Explanation of Changes:

Currently Plans are approved under planning application ref 211335/VAR for no 10, Angle field Road Reading RG4 5HP.

Figure 1- Approved plans front view under app. Ref: 211335/Var

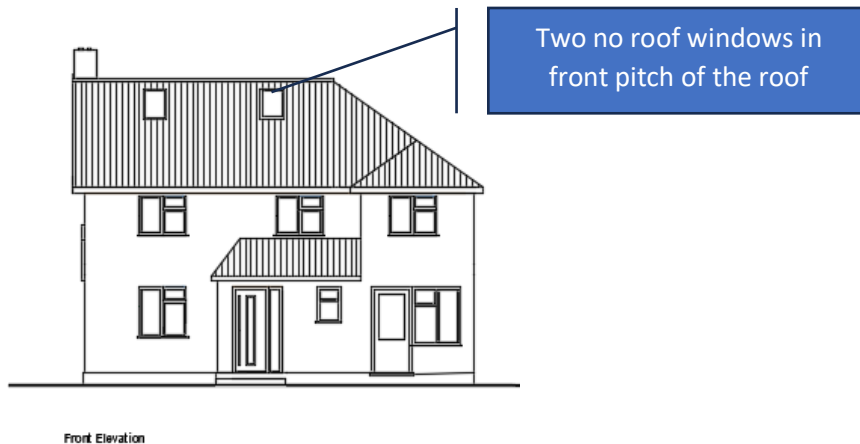
1. Change No 1 – Two no of roof windows in front Elevation are installed.

Figure 2- Front elevation with two number roof windows in this application

Figure 3: Rear elevation of the app. Ref: 211335/Var with 1.5m x 1.5m first floor windows

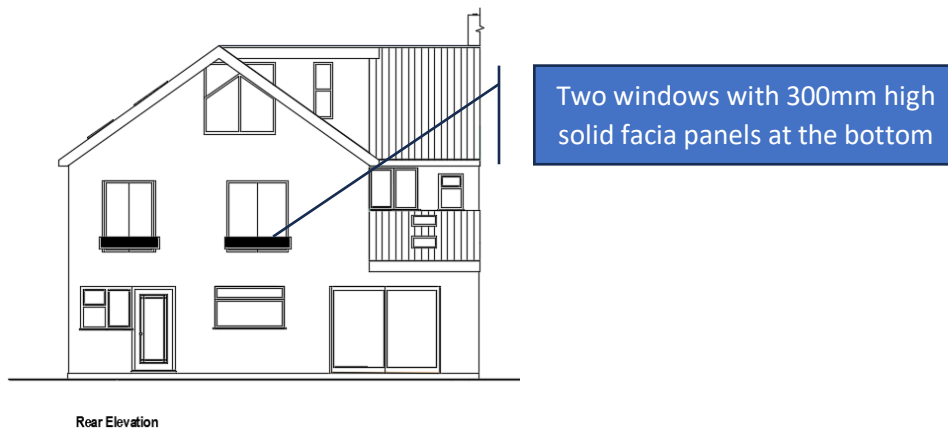
2. Change No 2- First floor windows to master bed room

In the approved plans, two number of first floor windows at rear elevation are 1.5m x 1.5m windows. Ground floor windows are unchanged.

Figure 4: First floor windows are 1.3m x 1.74m and 1.5m x 1.74m windows with 300mm wide solid bottom rails to cover the bottom 300mm of the window in this application.

Reason for change – This was constructed during covid lock down period. All window suppliers are not taking orders and also having a more than 6 months leading time. Therefore we chose to use the recycled windows from recycle window shop. There are so many houses in Caversham with similar windows. Please see figure 5.

Figure 5: Loft floor window is 1.5m x 1.5m window

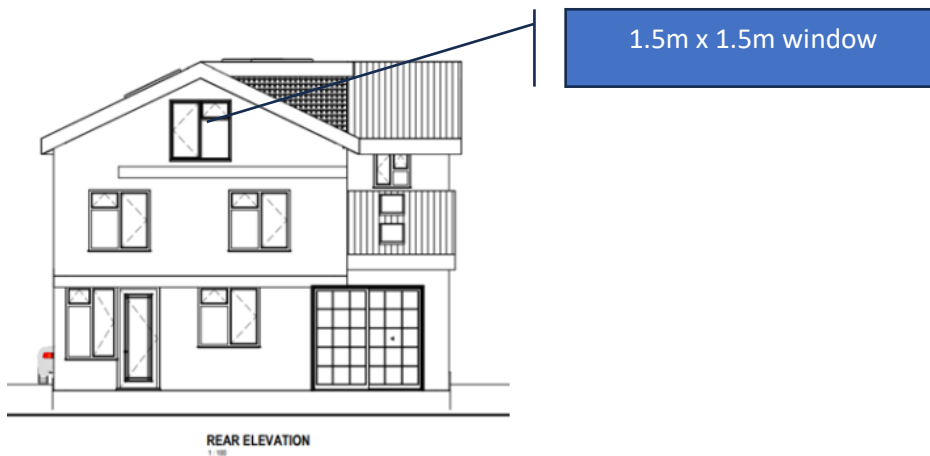
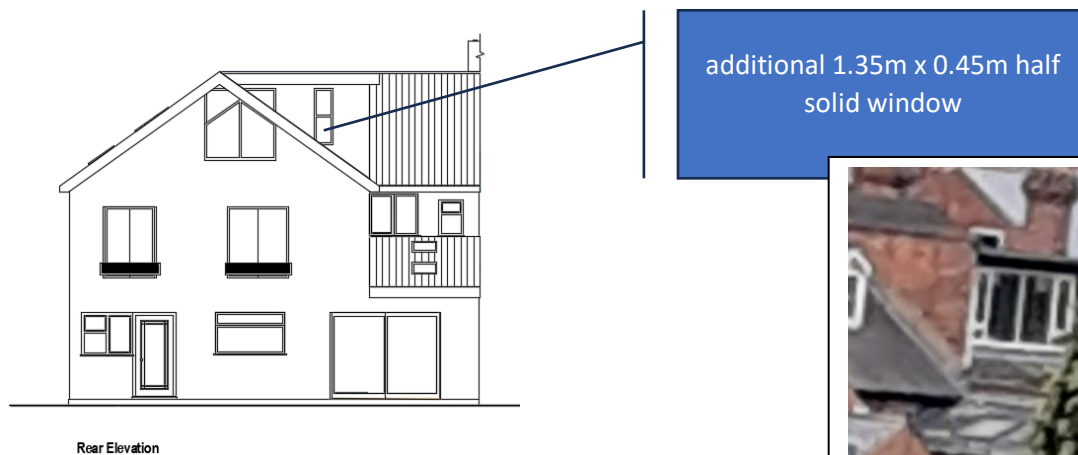
Change 3: Loft floor window size change

Figure 6: Loft floor solid glass window (unopenable) is 1.74m wide and 1.74m in height (240mm is bigger than approved plans) and additional window at the landing of 1.35m x 0.45m window with bottom half glass is fixed and top can be open 45degrees to vertical.
